Addendum NO 1

DATE: May 5, 2021

FOR: **Dallas County BRO-B030(10)**

ROCKSDALE RD BRIDGE #23800001
DALLAS COUNTY, MISSOURI
BRIDGE PLAN & ELEVATION

ROCKSDALE RD BRIDGE #23800001	ESTIMATED QUANTITIES & GENERAL NOTES
DALLAS COUNTY, MISSOURI

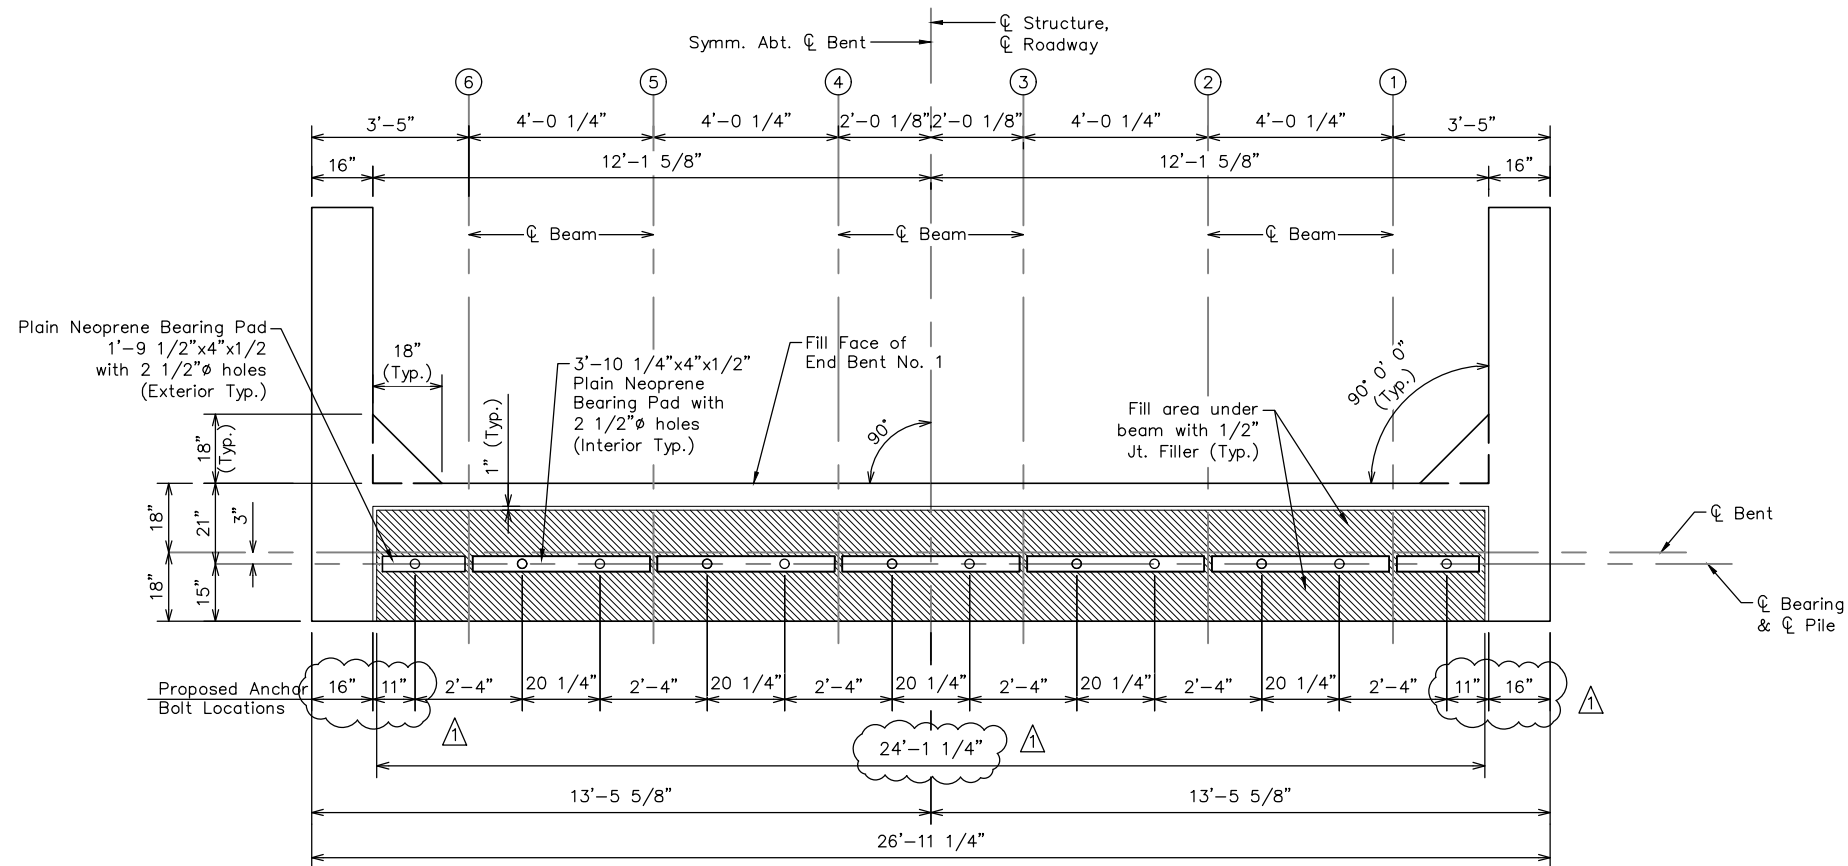
Sheet S2- Foundation Data Table has been updated to reflect HP 10 x 42 pile sizes. The Class B-1 Concrete and Reinforcing Steel quantities have been updated as a result of the bottom of encasement elevation change.

PLAN OF BEAM SHOWING DIMENSIONS

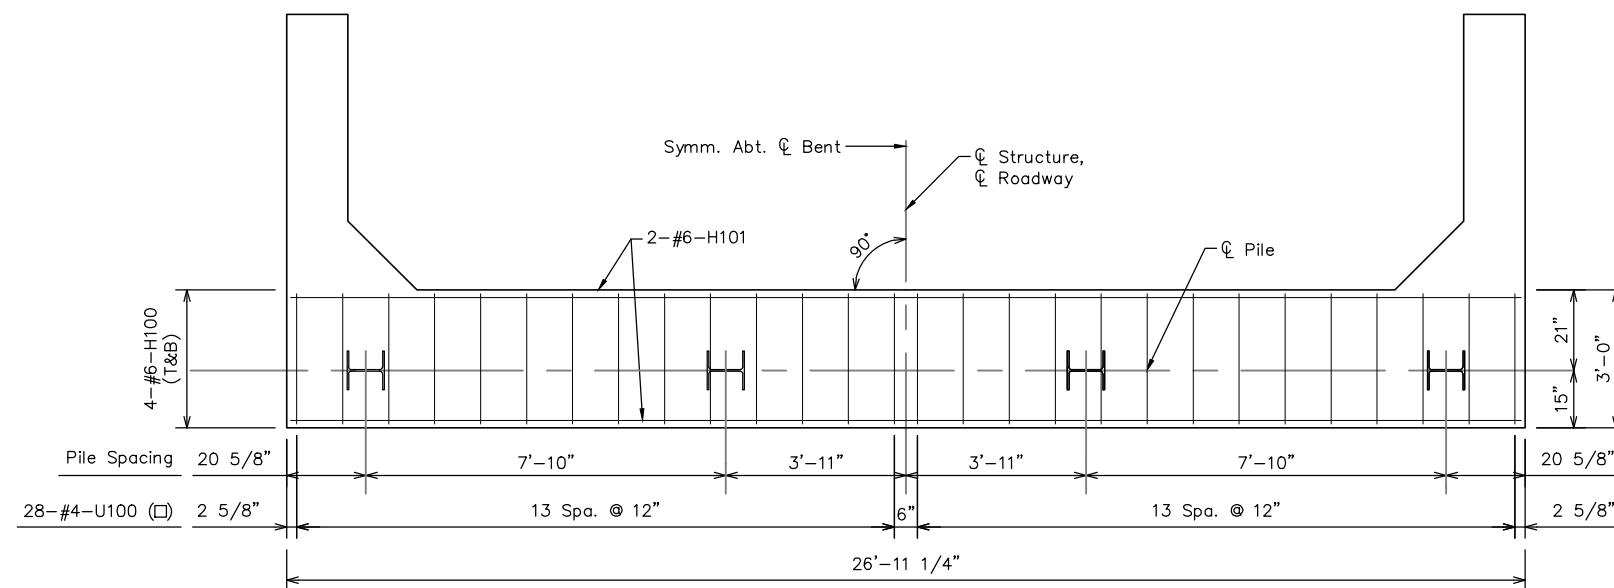
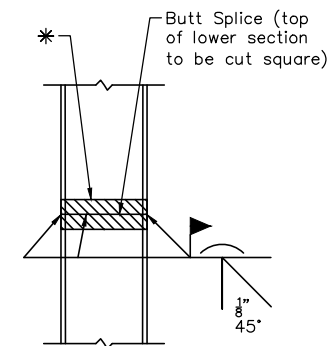
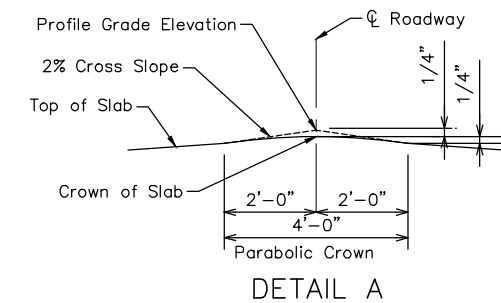
Sheet S3- End bent dimensions have been updated.

PART PLAN

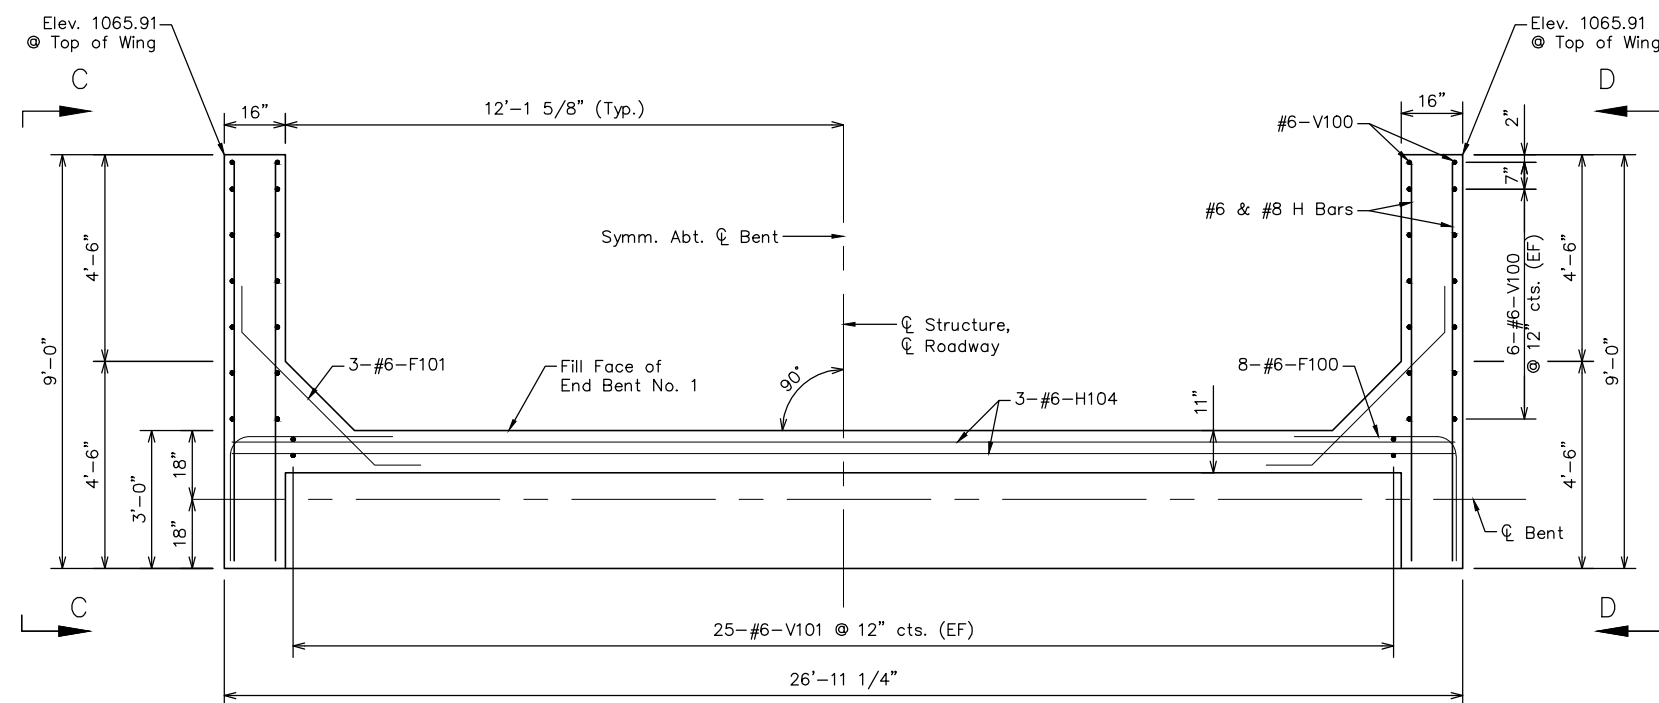
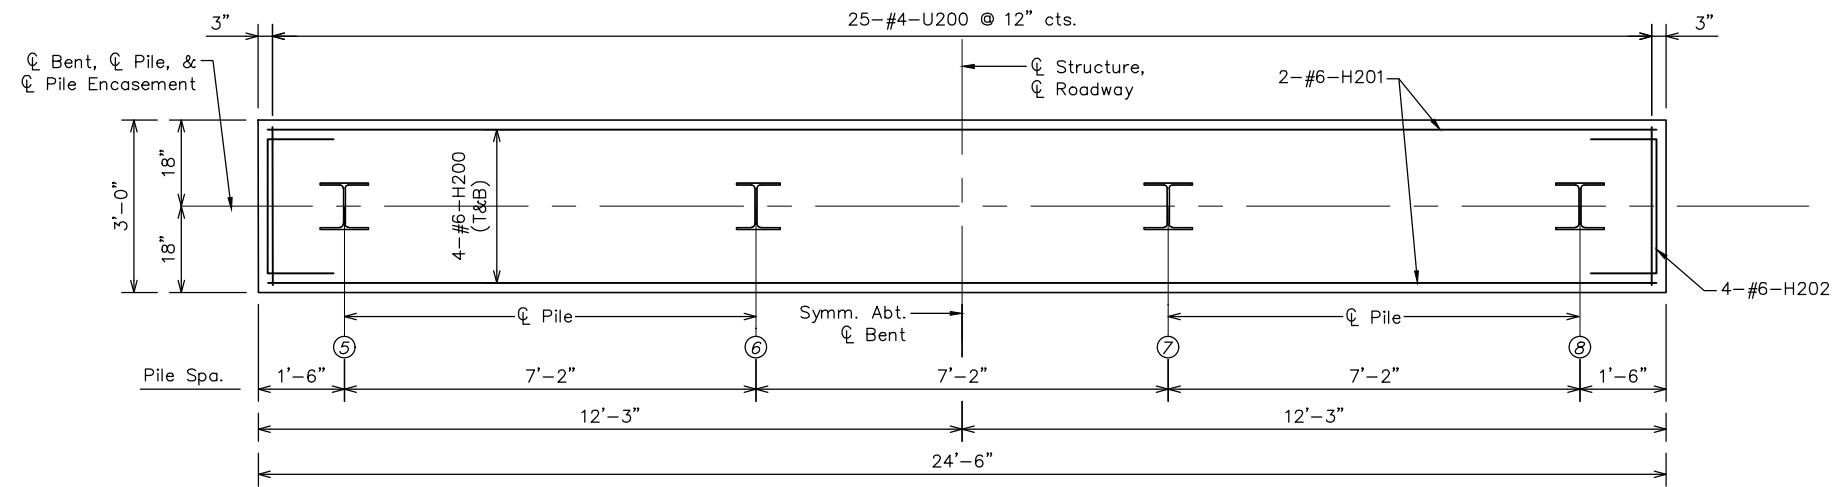
Sheet S4- End bent dimensions have been updated.

ROCKSDALE RD BRIDGE #23800001
DALLAS COUNTY, MISSOURI
DETAILS OF INTERMEDIATE BENT NO. 2

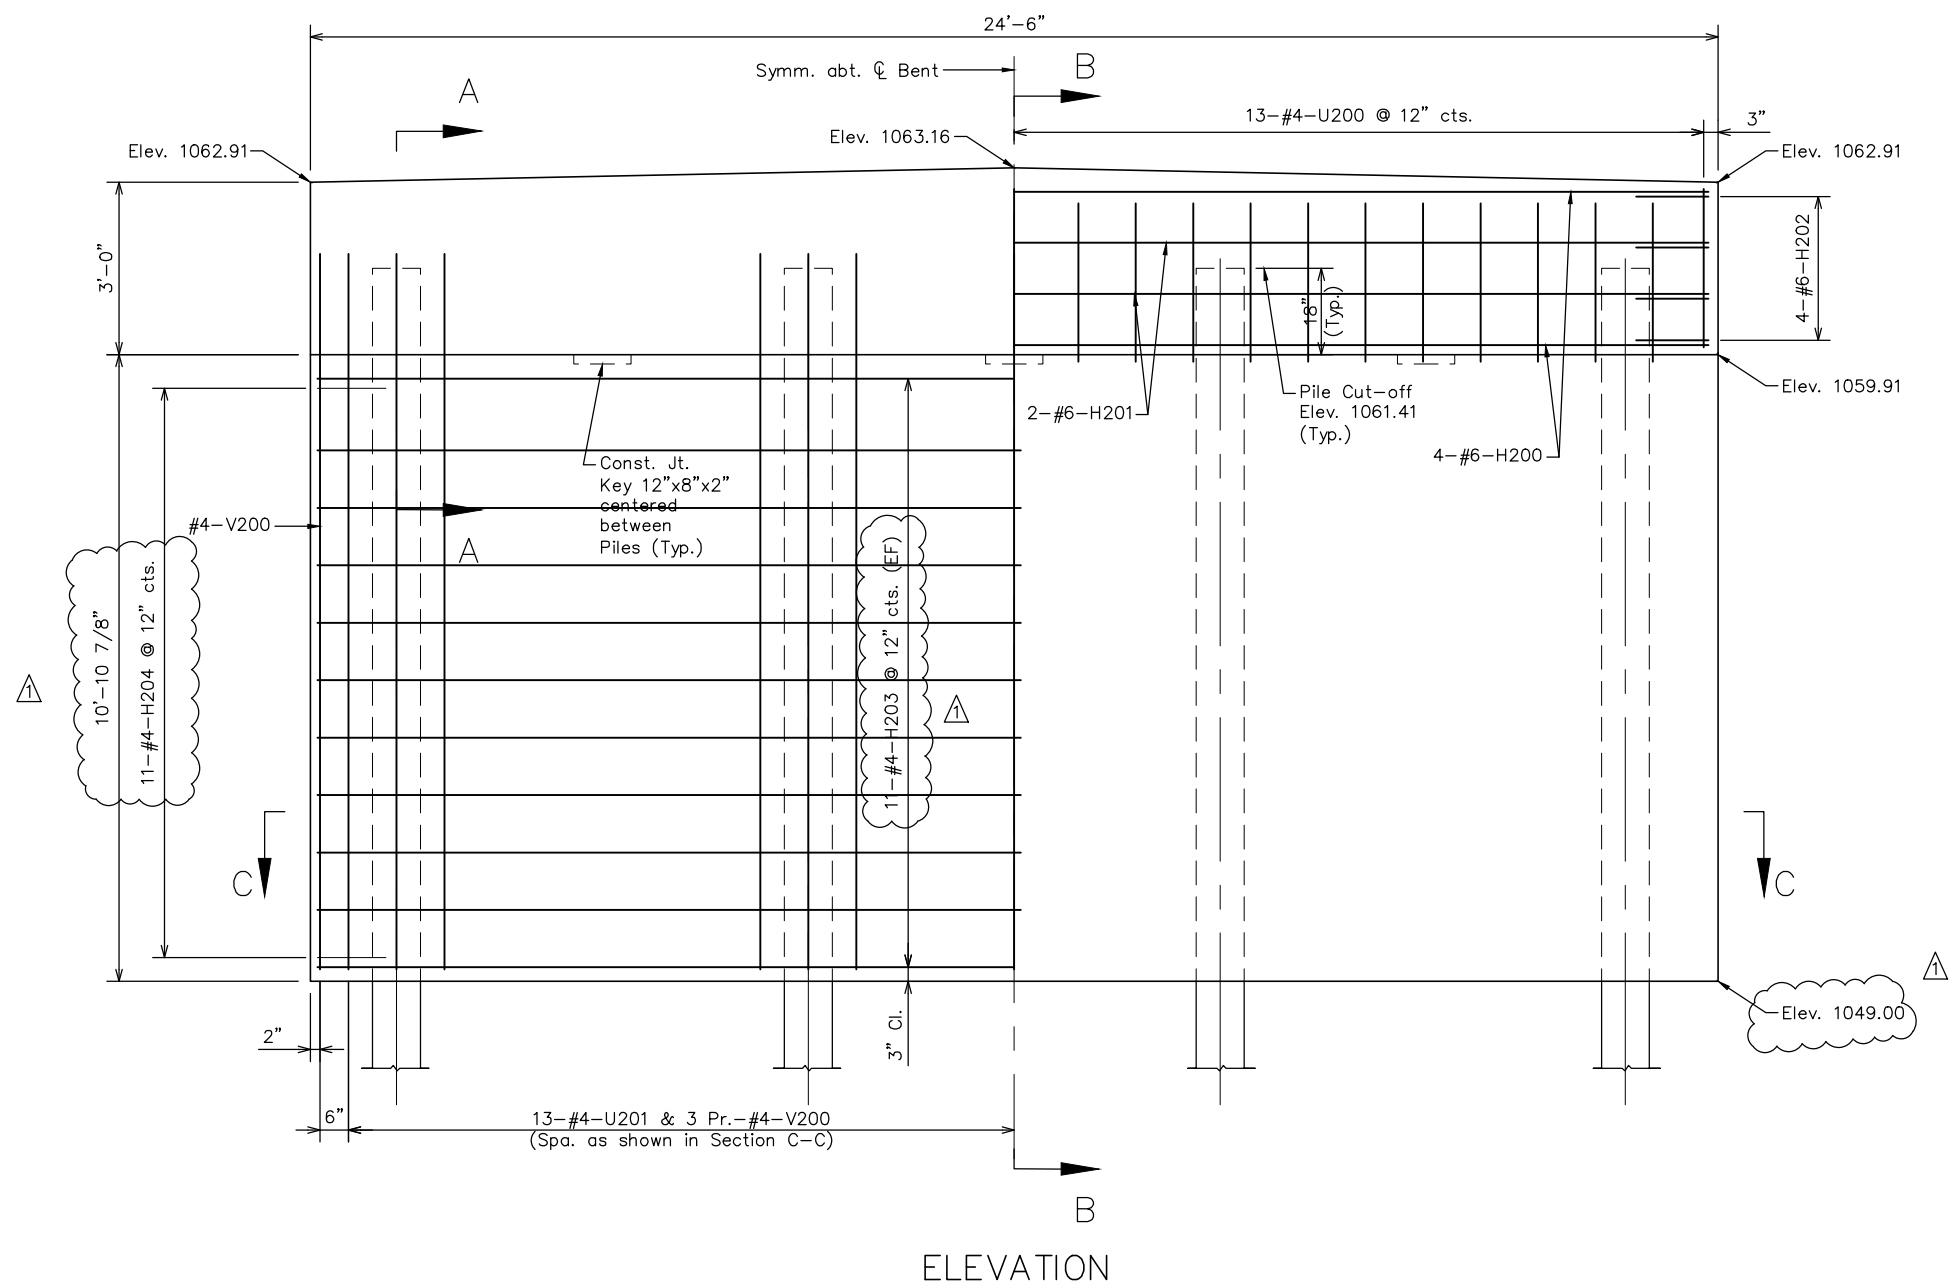
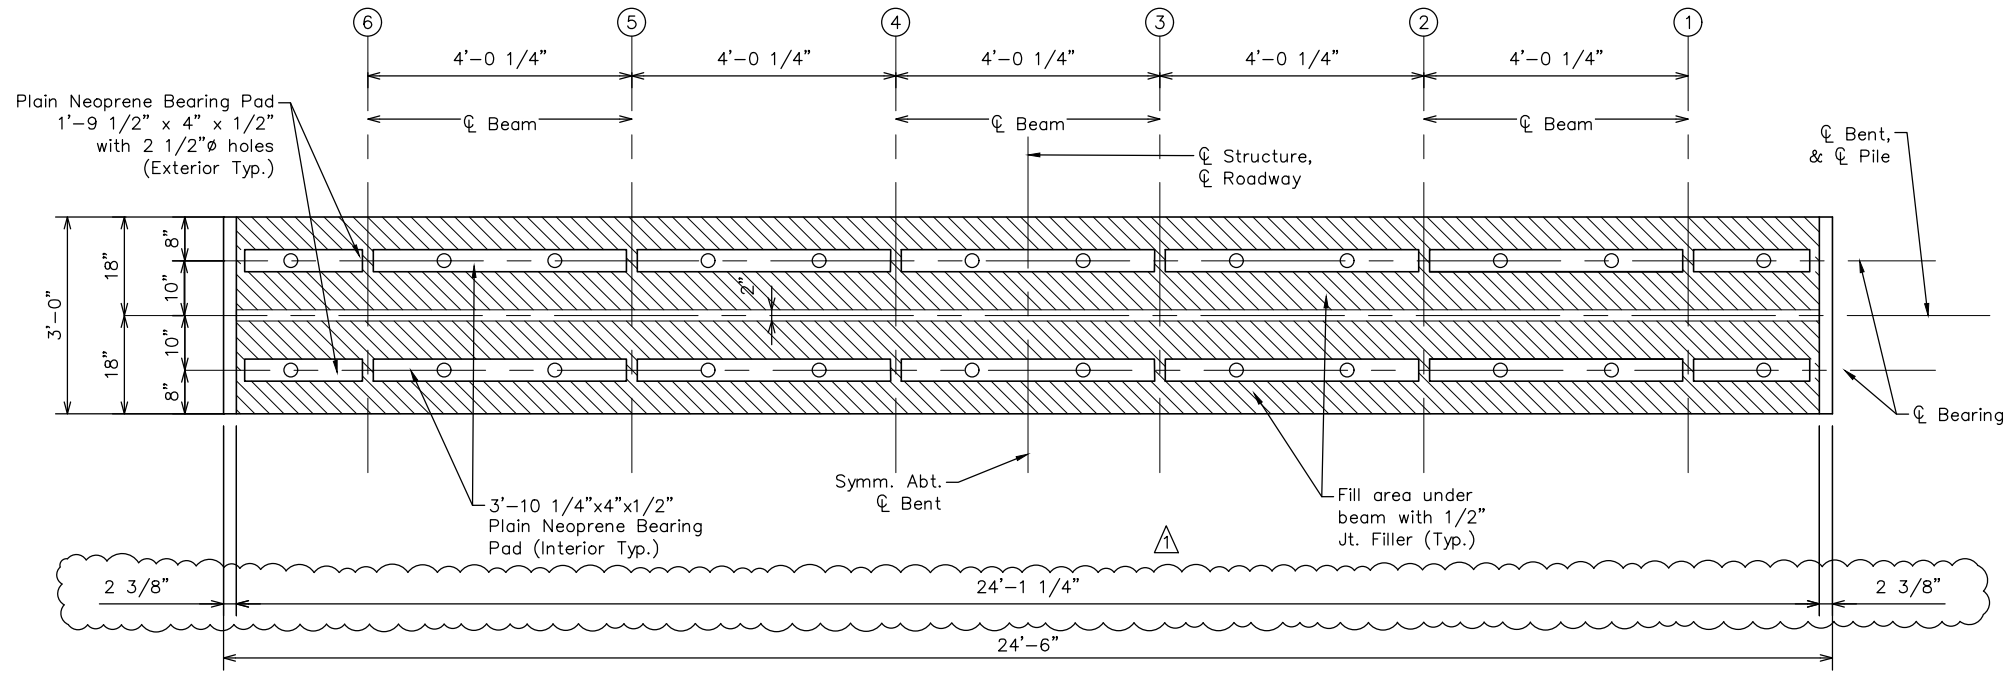
Sheet S6- The Bottom of Encasement Elevation has been changed from 1047.41 to 1049.00. The dimension for the height of the Encasement has been updated. The quantity of the H203 and H204 bars has been updated.
